Safety and Operations Committee

Board Information Item IV-A

Silver Line Phase 2 Update

Silver Line Phase 2 - Outstanding Issues

!! Concrete tie deficiencies

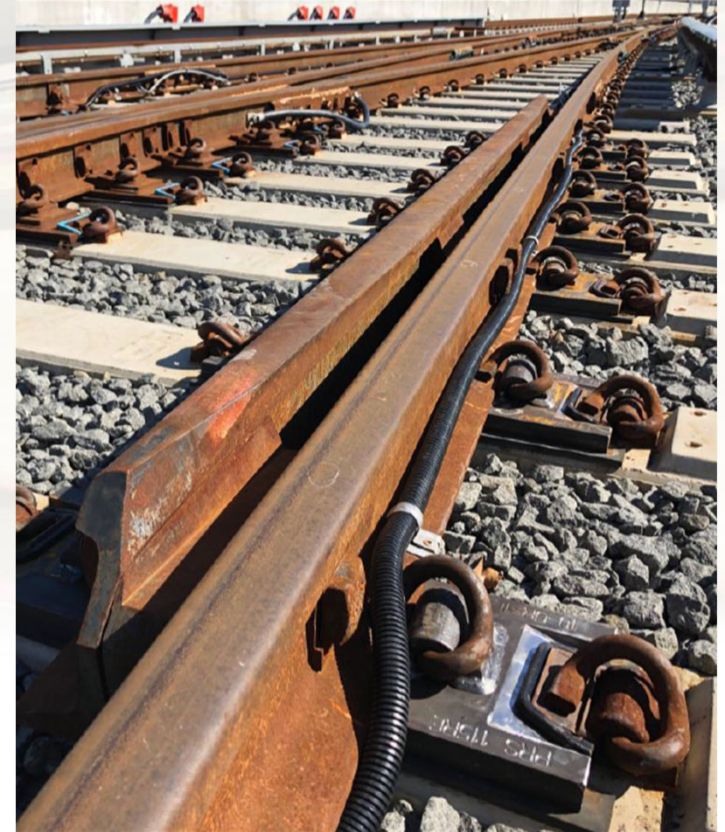
- Some concrete switch ties exceed contractual design requirements for allowable camber
- Remediation or replacement of cambered ties continues to be reviewed in conjunction with resolution of cross-level deficiency

✖ Track plate deficiencies

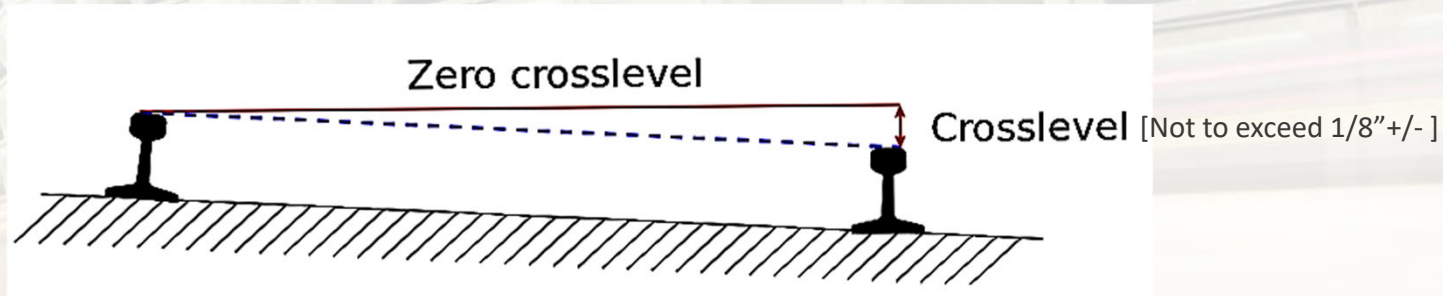
- Track plates at special trackwork exhibit curvature in excess of contractual design requirements for flatness creating gap between plate and tie
- Gaps at track plates may be resolved by remediation of cross-level deficiencies
- Metro will require remedy to address any gaps at track plates remaining that could result in fatigue failure

✘ Ballast deficiencies at Dulles Yard

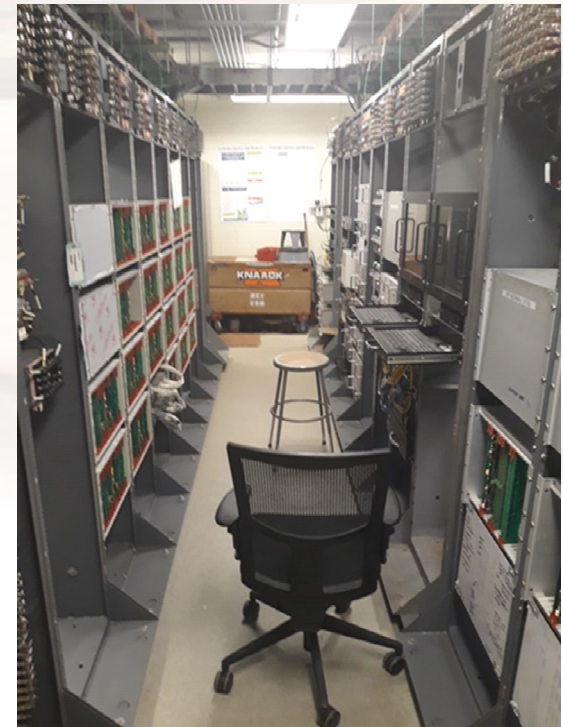
- Ballast contaminated with materials of inappropriate size/consistency; condition can lead to drainage issues, affect ability to constrain tracks, and pose a potential safety risk
- Metro OIG recommends complete survey and testing of ballast
- In addition to Airports Authority's 45 sampling location, Metro's consultant identified additional 45 sampling locations and test methods – collection of samples and sieving completed
- Results being reviewed by Metro's consultant
- Metro acceptance or rejection will be based on complete and thorough remediation of the fouled ballast in the Yard to meet required standards
